1997 - 1999: Service Bulletin: Engine Low Coolant Light Comes On (Inspect Rad. Surge Tank, Replace/Reposition)

Subject: Engine Low Coolant Light Comes On At Start-Up (Inspect for 2nd Design Radiator Surge Tank and Replace/Reposition)

Number: 99-06-02-016

Models: 1997-1999 Chevrolet Corvette (1997 Models Built Prior to VIN Breakpoint V5104277)

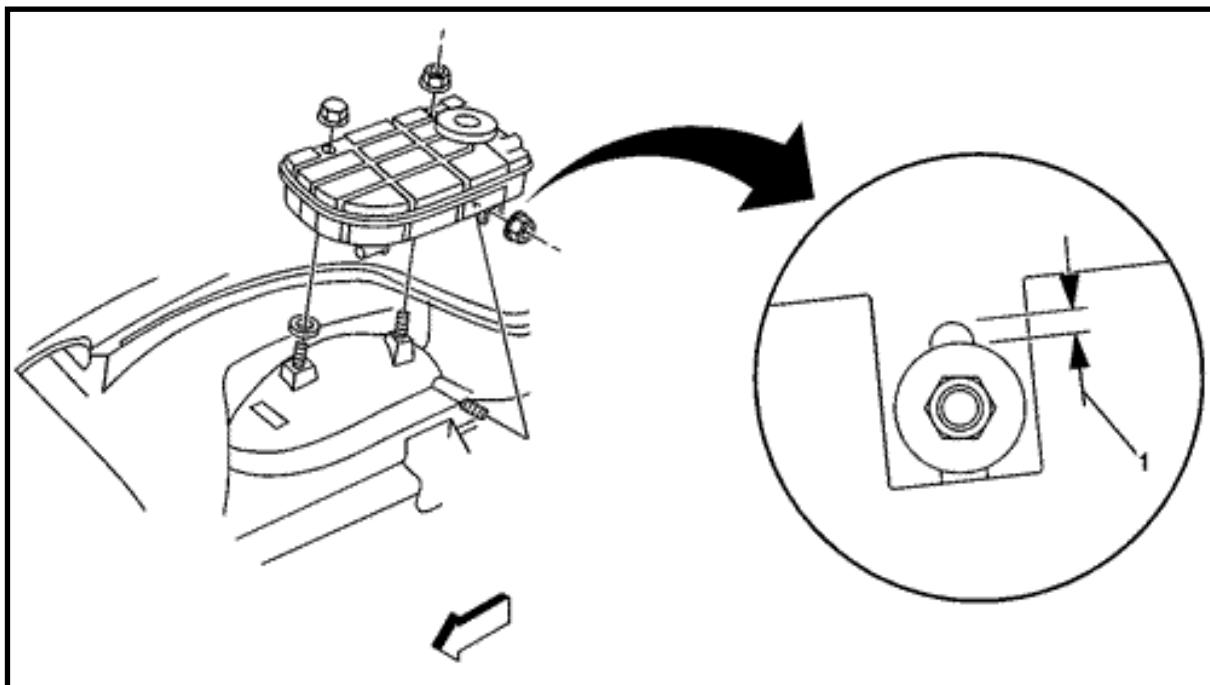
Cause: This condition may be caused due to the low coolant sensor being mounted in the rear of the radiator surge tank. When the vehicle is parked with the front lower than the rear, the coolant settles in the front half of the surge tank and with the switch in the rear of the tank, the switch float may be low enough to trigger the light. The "low coolant" light may come on if:

- The vehicle is a 1997 model, built before VIN V5104277, with the old design radiator surge tank.
- The radiator surge tank is improperly installed in the vehicle.
- The coolant level in the vehicle coolant system is low.
- The float in the tank is sticking.
- The coolant level switch connector is improperly connected.

1. For 1997 vehicles built prior to VIN breakpoint V5104277, replace the radiator surge tank and inspect for an out of position wiring harness under the tank. To repair the harness, position the harness downward and secure with a tie strap. To determine if the surge tank is of the first or second design, inspect the low coolant switch cavity in the surge tank. If the surge tank cavity extends 16 mm (5/8 in) below the bottom of the surge tank, the tank is of a second design tank. If the cavity is less than 15 mm (19/32 in) replace the tank with P/N 10405218.

2. For all vehicles, check the level of the tank by viewing the lower mount on the tank. Less than 2 mm (.08 in) (#1) of the mounting slot should be visible above the attaching nut. If the gap is greater than 2 mm (0.08 in), loosen the surge tank and hold in a downward position to achieve less than a 2 mm (0.08 in) gap above the attaching nut. Tighten the bottom nut first, then both top nuts. **Tighten**

Tighten the nuts to 10N·m (89 lb in).
